Ballard Link Extension

To: Stephen Mak, Sound Transit

From: Salima Hamlin, HNTB

Re: 4th Avenue Shallow Alignment Schedule Analysis Response - Summary

Figure 1: Create multiple construction access

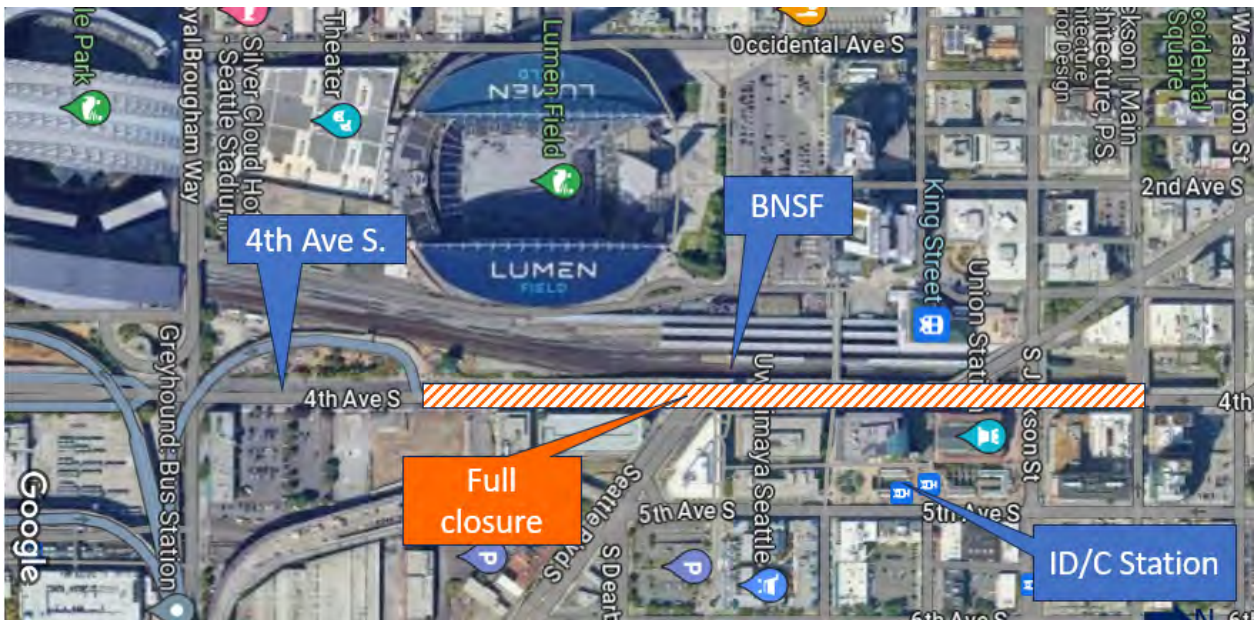
A potential reduction in the construction duration from 12 years to 9.5 years was identified on the assumption that quicker construction access could be provided by constructing additional temporary access ramps from Seattle Blvd S. (savings of 1 year) and 4th Avenue S./S. Main Street (savings of 3 years) into the construction area (see Figure 1).

The VMS team also suggested combining multiple stages by constructing one side at a time from the I-90 off-ramp to S. Main Street. Subsequent assessment by the project team determined that combining multiple stages, and thus construction along the entire length from the I-90 off ramp to S. Main Street, would take longer as it would require construction of the support of excavation (SOE) and dewatering of the entire length before starting the critical path work at the station location south of S. Jackson Street. In addition, the site has limited staging area and there would also be a limited capacity of crew and equipment to facilitate all the work in one stage.

Subsequent assessment by the project team determined that these additional access points were either not practical or did not provide schedule savings for the reasons noted below:

- Access ramp from Seattle Blvd: An access ramp from Seattle Blvd is not practical because there is not sufficient length to ramp down without affecting existing light rail operations and the Union Station Garage access.
- Access ramp from 4th Ave S./S. Main Street: An access ramp would require a considerable amount of time to construct due to work adjacent to BNSF tracks, minimal available space for construction, potential conflict with S. Jackson Street Bridge, and the presence of the counterfort retaining wall that currently supports the 4th Avenue S. roadway. This would likely negate much of the schedule savings identified by the VMS team.
- Being in a constrained environment, both access points would also require time to reconstruct back to existing conditions, further reducing potential schedule savings.
